ATTACHMENT TO LER 80-08, Rev.1
CONSUMERS POWER COMPANY
PALISADES PLANT
DOCKET 50-255

FIGURE 1

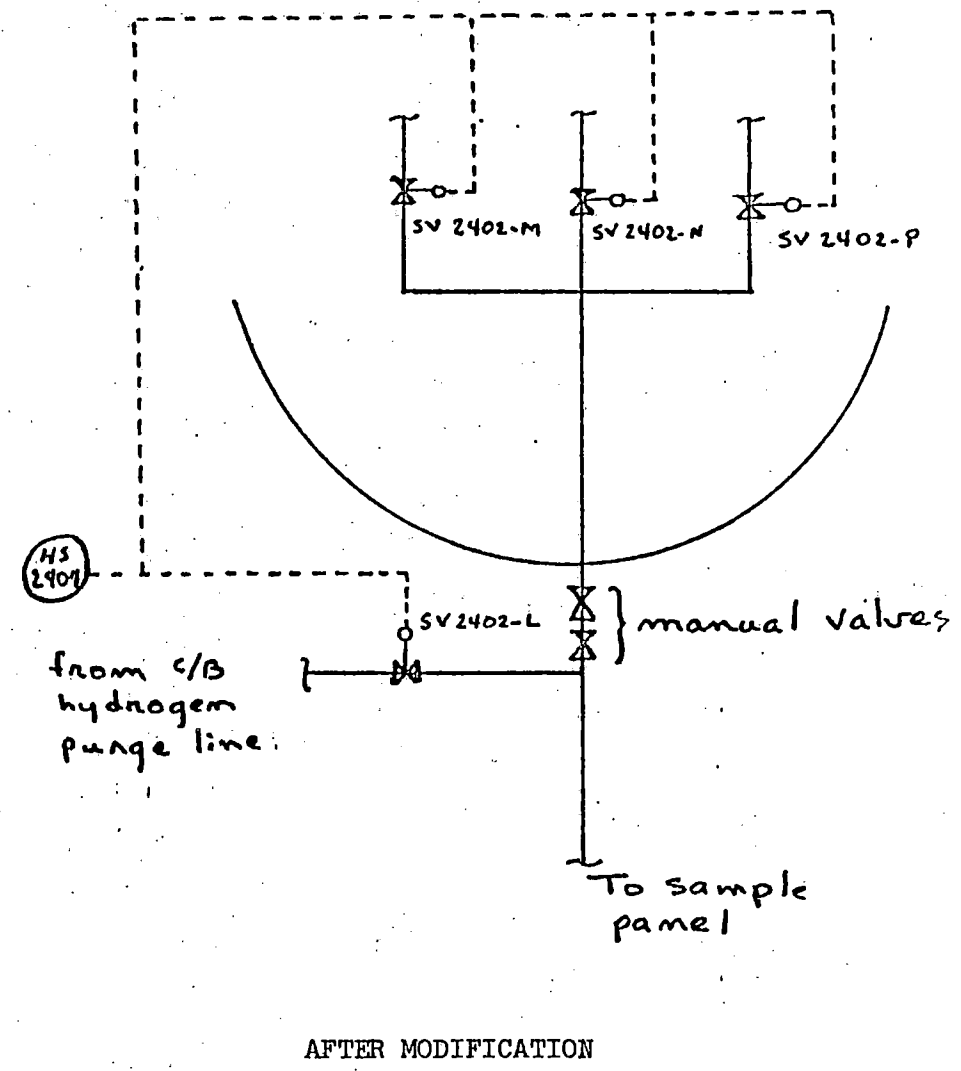
Refer to Figure 1 for the following discussion. Regarding penetration 28 (containment air sample) the design of the handswitch which operates the solenoid valves is such that one of the solenoid valves (2402-L,M,N, or P) is always energized (open). As a result, a single valve boundary existed between containment atmosphere and the containment hydrogen vent line.

This penetration has been modified by the addition of two manual valves which provide containment isolation. Additionally, valve SV-2402-L was previously oriented such that it provided an essentially leak-tight boundary for flow from the hydrogen exhaust line but not in the reverse direction. The valve orientation has been reversed such that leakage through the valve should not occur during containment sampling operations.
